MEMORANDUM

SUBJECT: July 28, 2026 HISTORIC PRESERVATION COMMISSION MEETING

STAUNTON HISTORIC PRESERVATION COMMISSION**June 23, 2026****5:30 p.m.****Council Chambers**

HSF Recommendation

Add flue pipe for a new interior wood burning stove

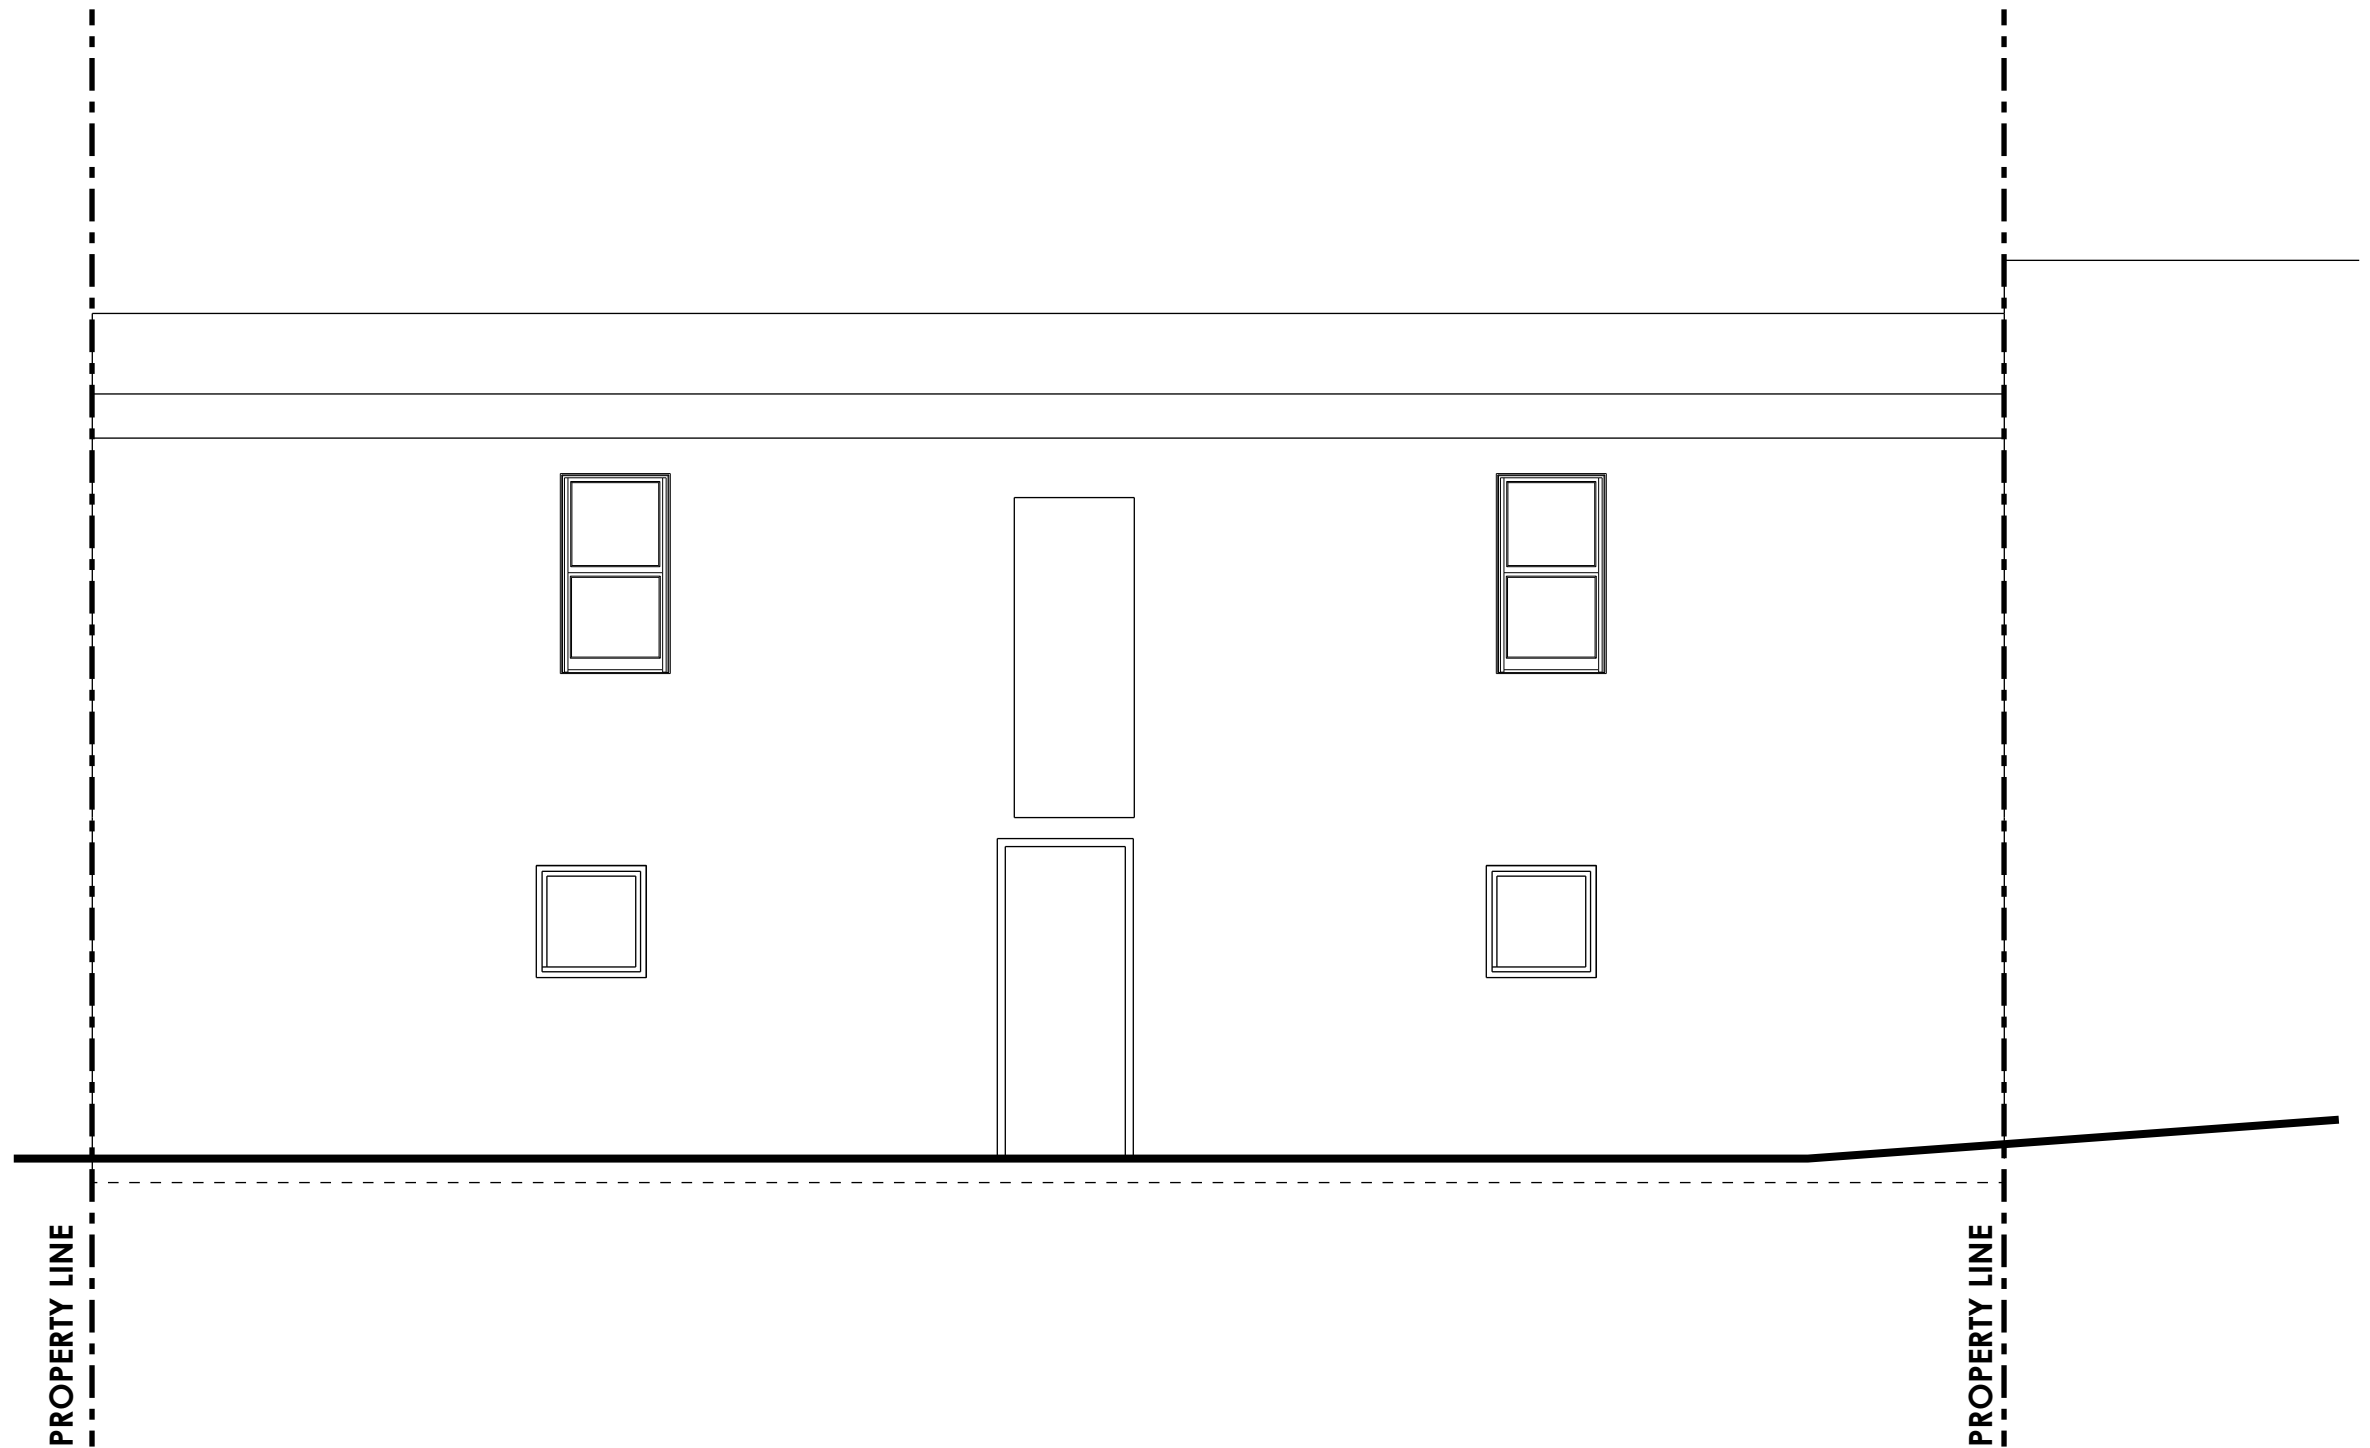
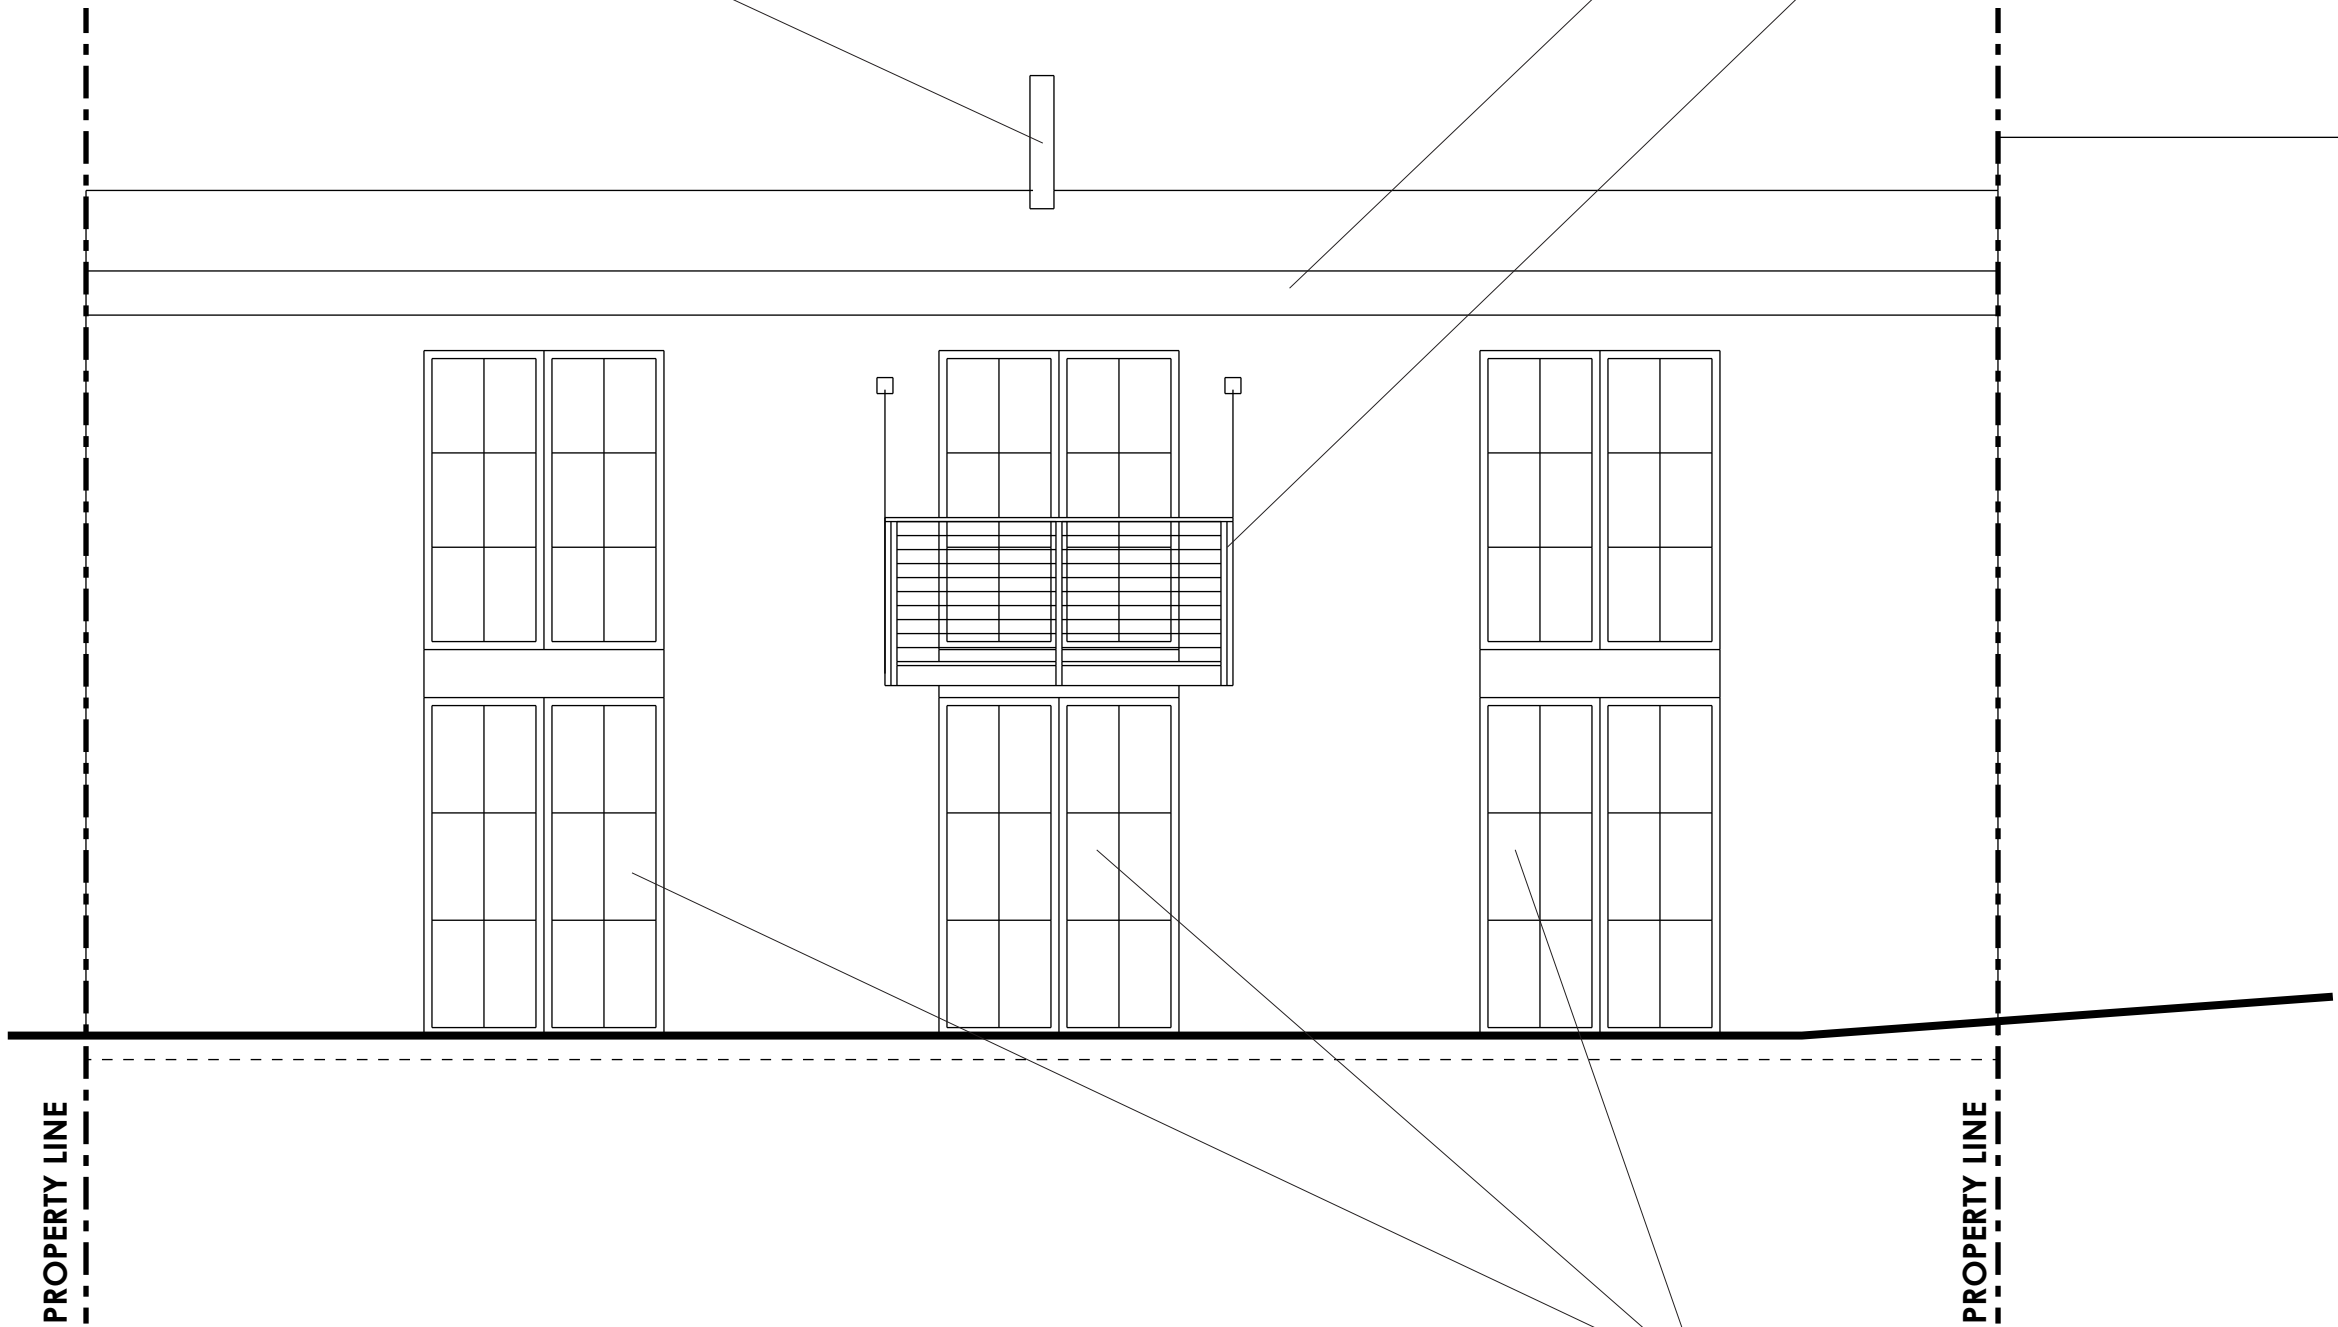
- Add glass panels to the top two rows of the existing garage doors.
- Paint garage doors black
- Add flue pipe for a new interior wood burning stove

The rail and style construction with panels allow a retrofit of the upper panels with glass lights, reflecting the character of early 20th Century garage doors. Therefore, the change alters an existing replacement door by adding compatible glass panels.

Paint existing fascia and soffit black

Paint existing garage doors and header black

Add glass panels to the top two rows of the existing garage doors. Paint garage doors black

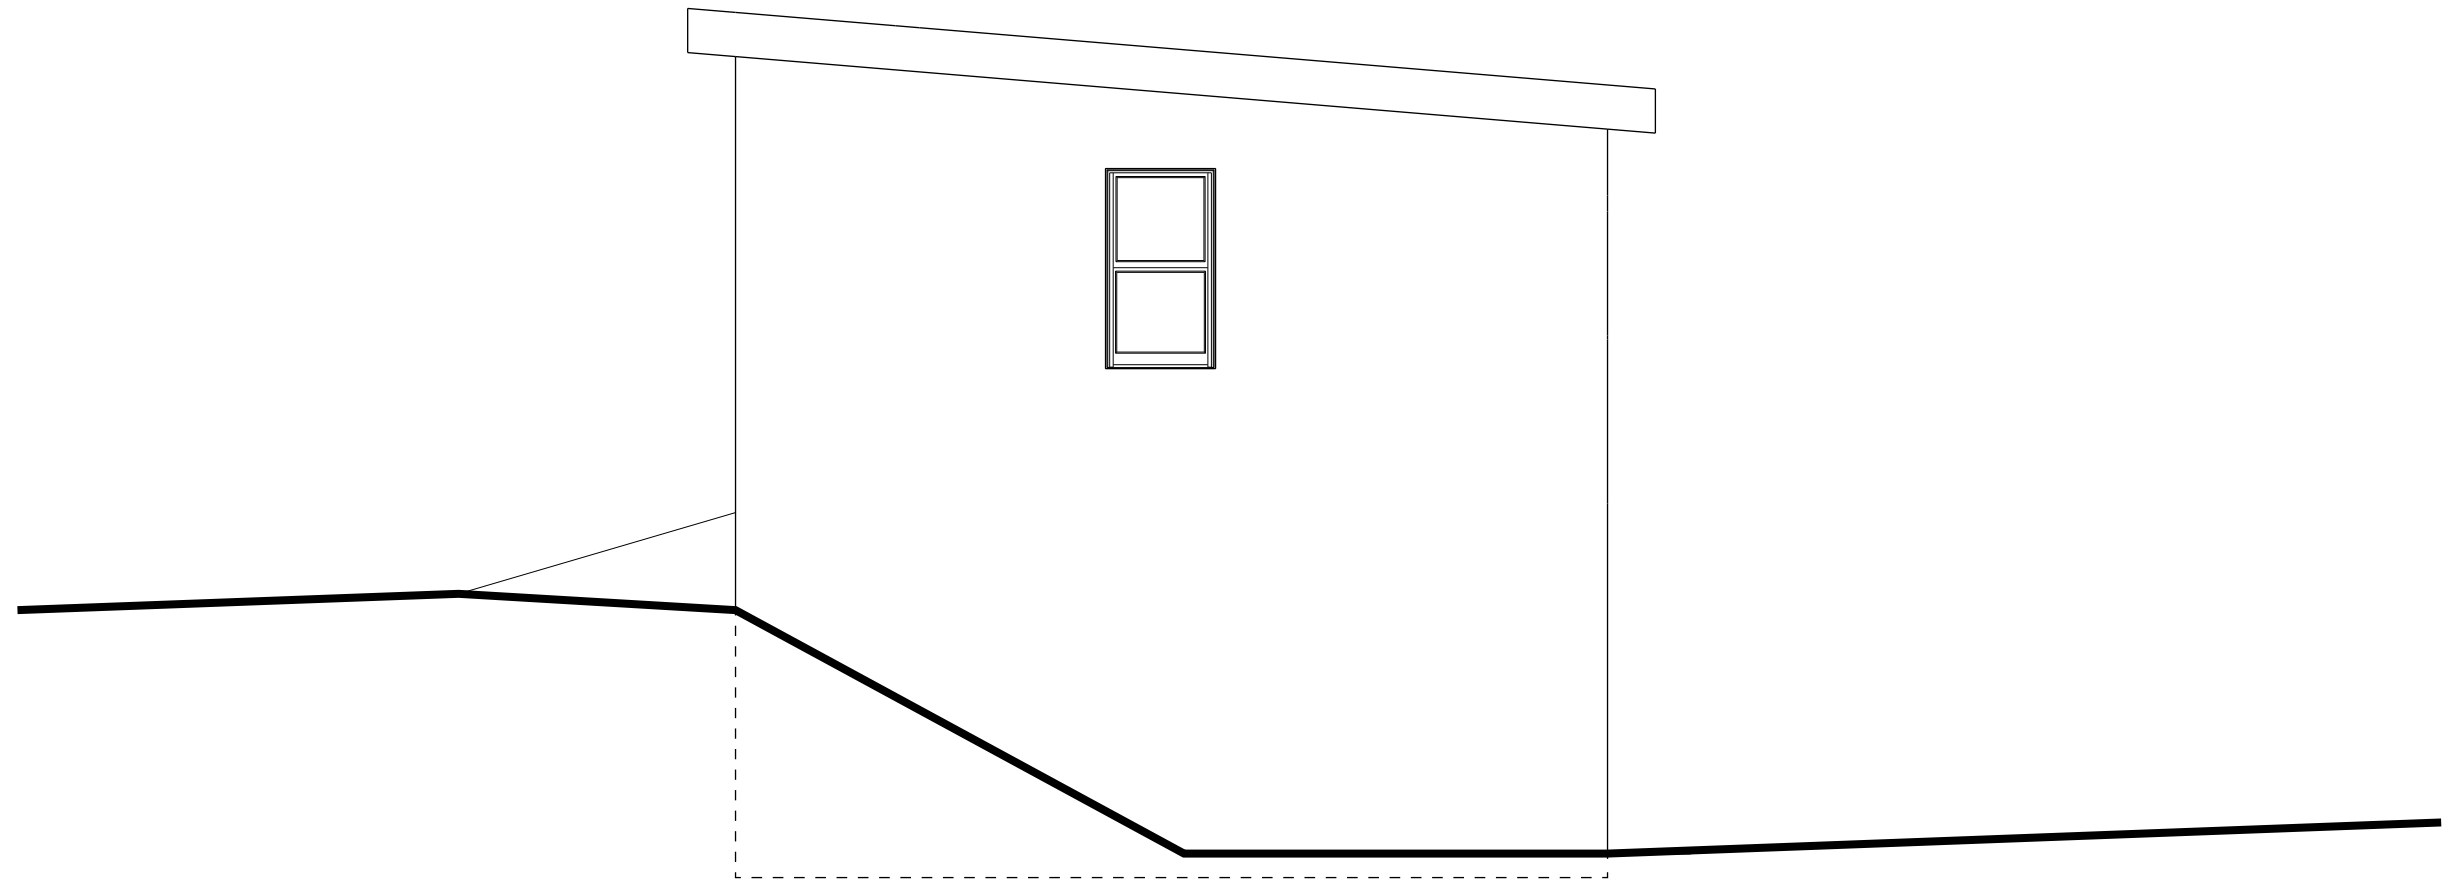
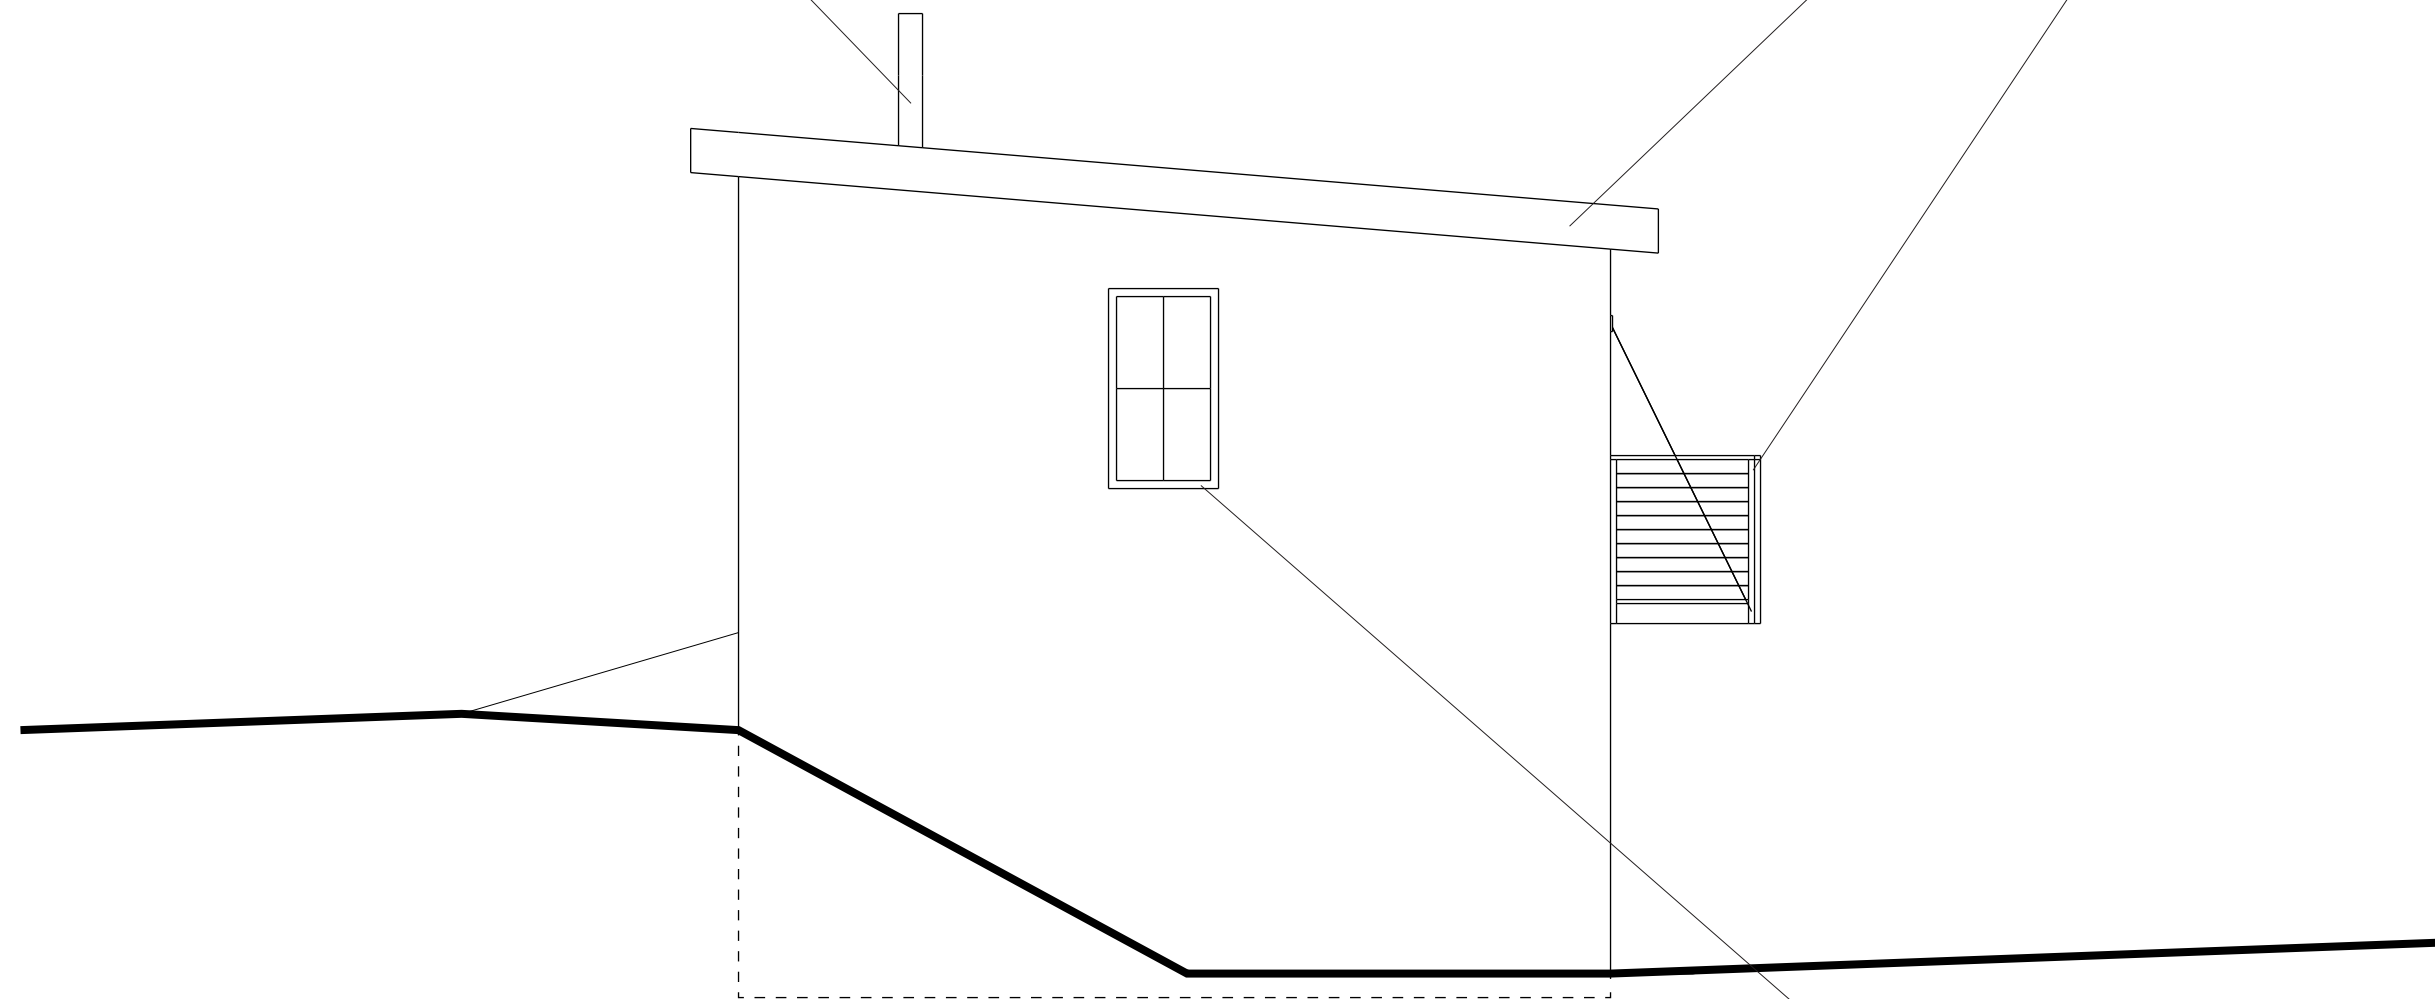
Add a 3'x7' balcony to the East facade

Add a 3'x7' balcony to the East facade

Replace the existing window on the South Facade with a new black aluminum clad window
